Proposal for amendments to ECE/TRANS/WP.29/2017/10

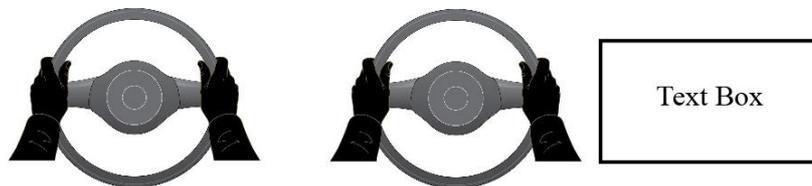
- 5.6.2.2.5. When the system is active (~~i.e. ready to intervene or intervening~~) and in the speed range between 10 km/h or V_{min} , whichever is higher, and V_{max} , it shall provide a means of detecting that the driver is **[firmly]** holding the steering control **[as declared by the vehicle manufacturer]**.

If, after a period of no longer than 15 seconds the driver is not holding the steering control, an optical warning **signal** shall be provided. **This signal may be the same as the signal specified below in this paragraph.**

The optical warning signal shall indicate to the driver to place their hands on the steering control. It shall consist of pictorial information showing hands and the steering control and may be accompanied by additional explanatory text or warning symbols- see examples below:
